**Explanation of Significant Differences
Landfill Cap Redesign
IR Site 1, Tidal Area Landfill**

**Naval Weapons Station Seal Beach
Detachment Concord
Concord, California**

May 22, 2008

A	Navy Responses to Regulatory Agency Comments on the Draft Technical Memorandum Landfill Cover Redesign, IR Site 1, Tidal Area Landfill
B	Revised Landfill Cap Plans
C	Revised Construction Specifications
D	Settlement Evaluation
E	Slope Stability Evaluation
F	Supplemental ARARs Evaluation

**FIGURE 6
PRELIMINARY SITE 1 LANDFILL CAP PROJECT SCHEDULE
Naval Weapons Station Seal Beach Detachment Concord**

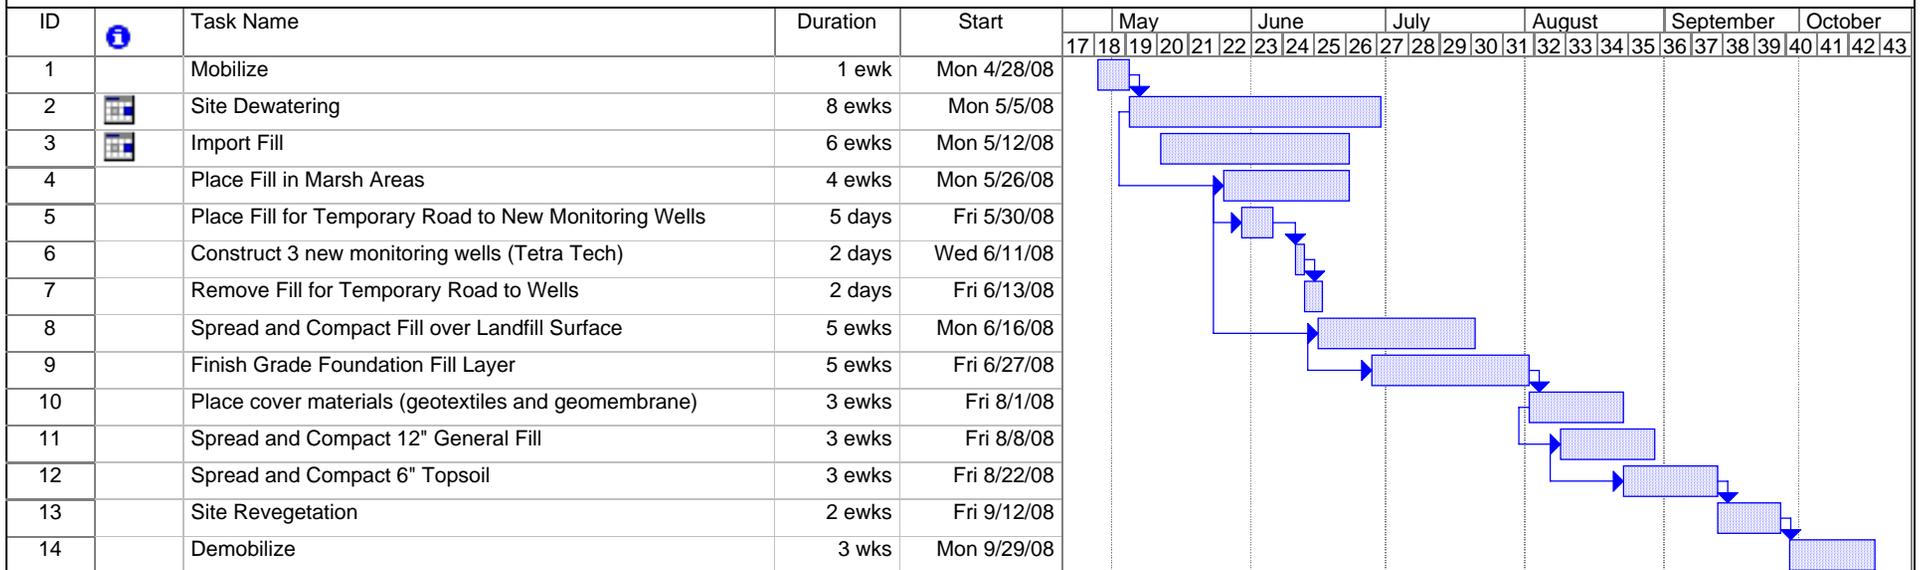
1. **Comment:** **Schedule: We request a revised schedule for the completion of the landfill cap.**

Response: A revised schedule is included in the ESD document as Figure 6.

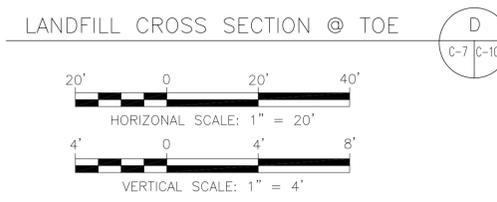
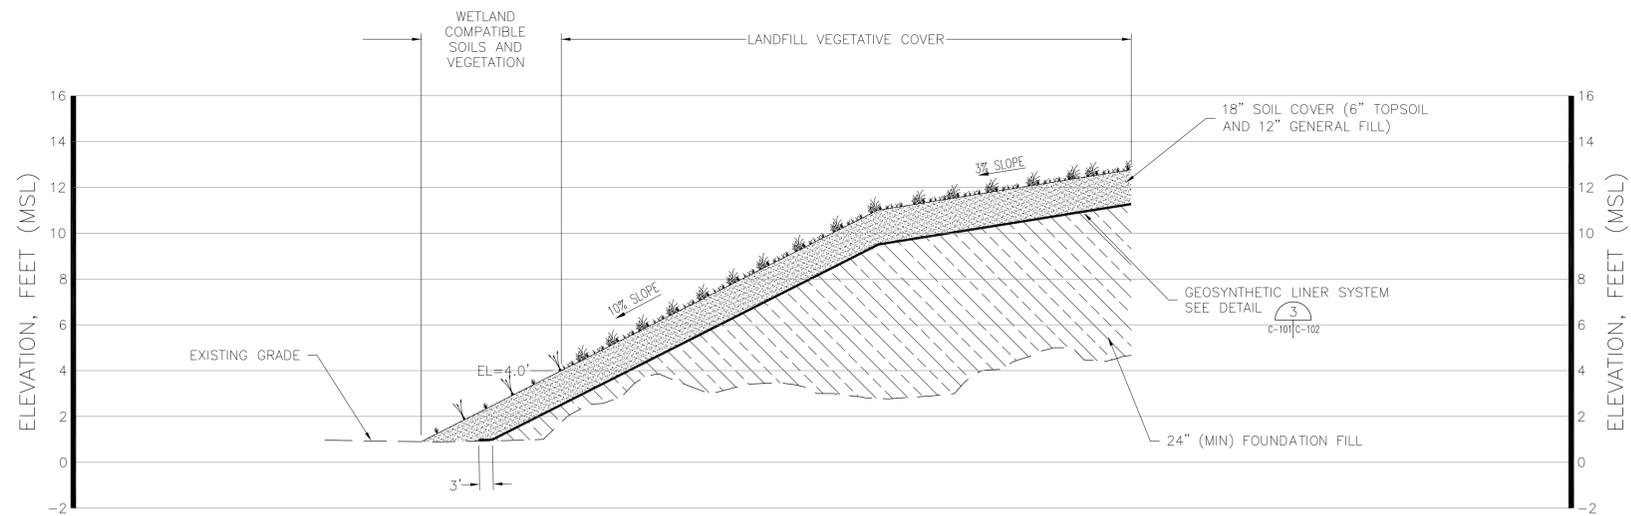
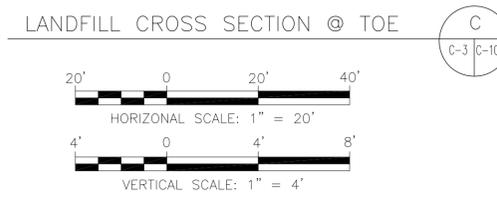
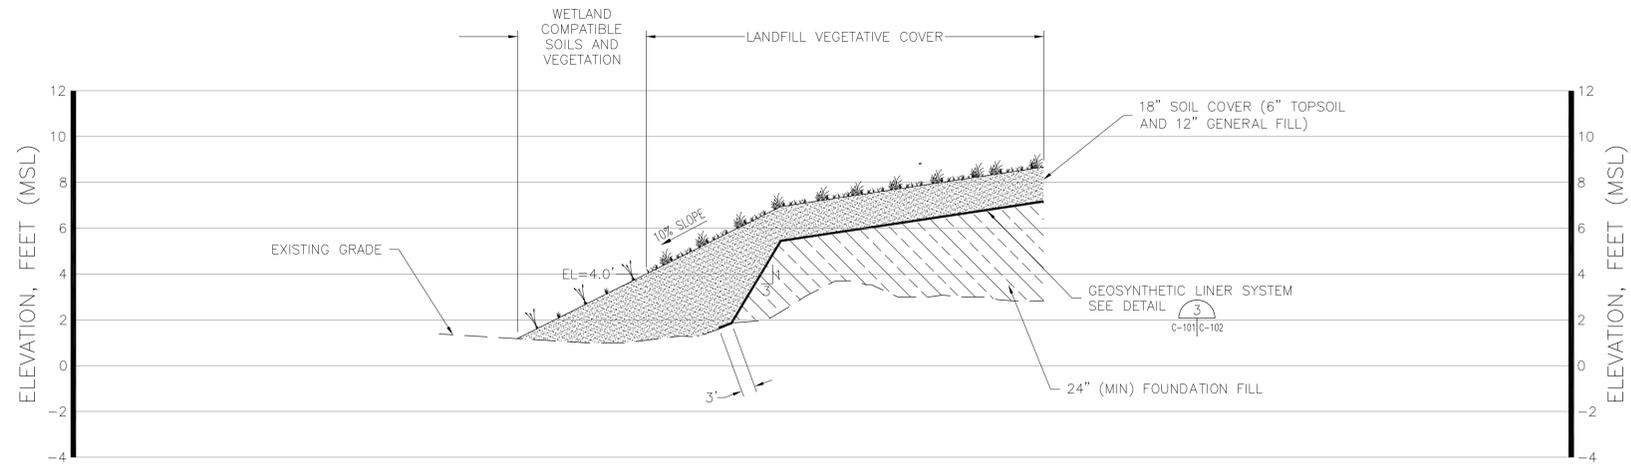
4. **Comment:** Section 4.5, Protectiveness of the Remedy, Page 15: One potential long-term concern that is not addressed in this section or in the design is the effect of sea level rise. As shown in Drawings C-100 and C-101, the toe of the south and west sides of the soil cover will be approximately 1 foot above sea level. The north and east side toes will be approximately 5 to 6 feet above sea level. According the U.S. Geological Survey Fact Sheet 175-99 (<http://pubs.usgs.gov/fs/1999/fs175-99/>) the Fort Point gauging station next to the Golden Gate Bridge has recorded sea level increases averaging 0.04 to 0.08 inches per year since 1900. This rate may accelerate during the next 100 years. In addition to rising sea level, abnormally high tides are not unknown in the San Francisco Bay region. The same USGS Fact Sheet notes the occurrence of high tide at 5 feet above mean sea level on February 3, 1998, due to the El Nino that year. Although the extent of sea level rise is uncertain, extreme high tides accompanied by wind storms and heavy wave action can be confidently predicted to occur several times during the 30 to 50 year design life of the cover proposed for the Tidal Area Landfill. Please address the long-term stability of the proposed cover considering sea level rise, and under abnormal high tide (5 ft. AMSL) and wind storm conditions.

Response: Covering the landfill waste with a relatively impermeable synthetic barrier from above combined with the relatively impermeable natural geology from below is intended to provide hydraulic isolation of the waste from the surrounding environment. Because of the hydraulic isolation of the waste, significant groundwater flow is not expected under the cyclic diurnal tide conditions, which will exert only relatively low water pressures. Extreme tides driven by low atmospheric pressure or flooding are of short duration and are also not expected to have significant impact. Sea level rise, although persistent, is gradual and is not expected to result in any significant persistent hydraulic gradient at the site. The groundwater monitoring program is intended to monitor the surrounding area to verify there are no impacts from contaminated leachate. The landfill design accounts for short-term tidal fluctuations, flooding, and the persistent rise in sea level.
